**Amendment to the Drawings**

Attachment: Formal Drawings of Figs. 1-8 (8 sheets).

FIG. 5

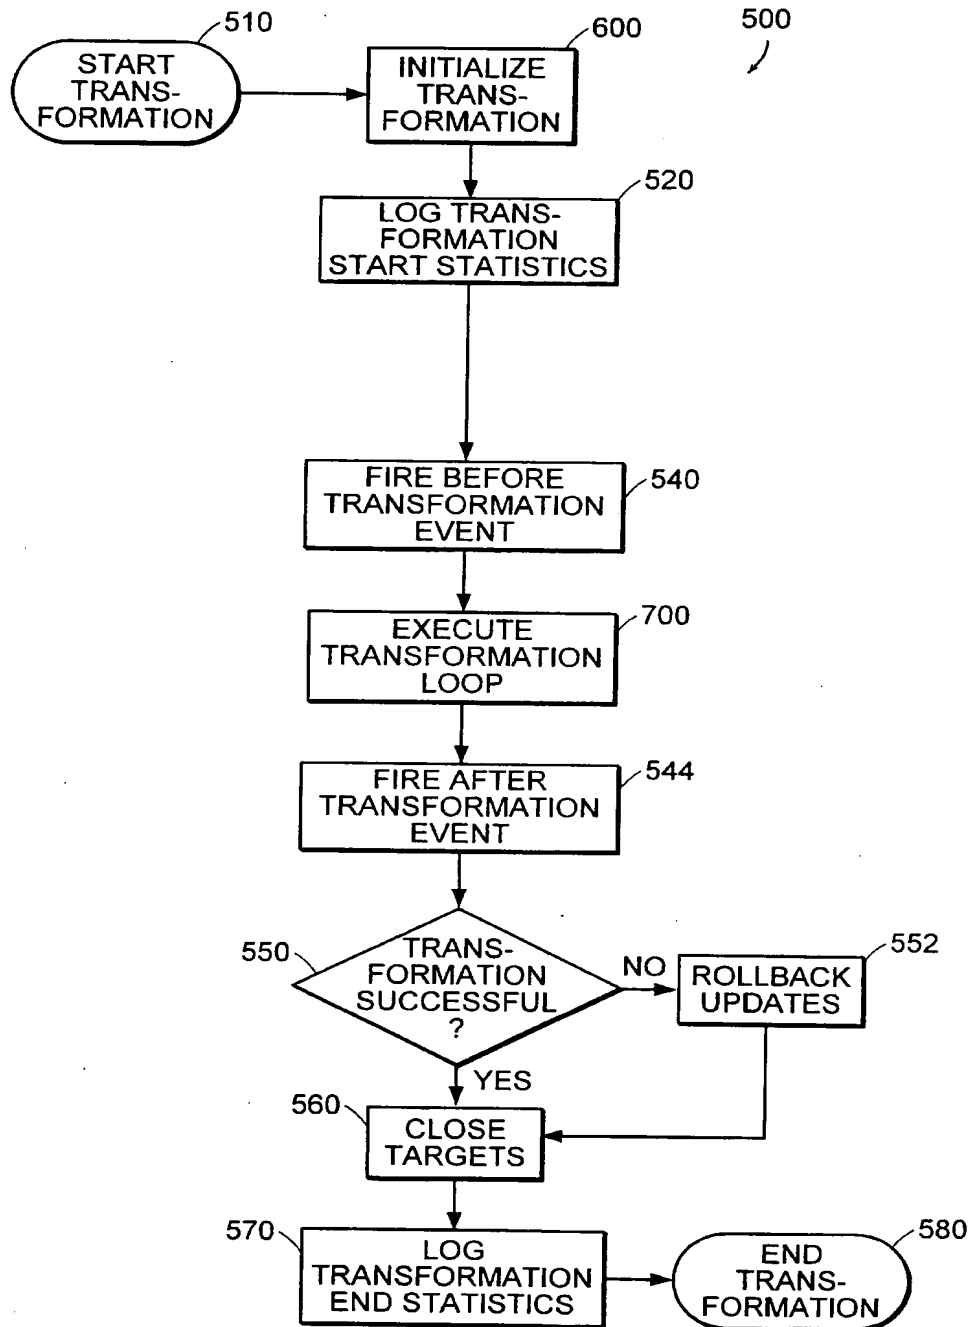
Attached are formal drawings (8 sheets) of Figs. 1-8. The drawings include a change to Fig. 5 to correct a typographical error in block 544. In particular, the word "AfterConversion" has been changed to "AfterTransformation." Support for such a change may be found, for example, on page 49, lines 27-28, of the specification. The amendment to Fig. 5 is submitted for clarification purposes only and does not present new matter. Approval of the submitted changes by the Examiner is requested.
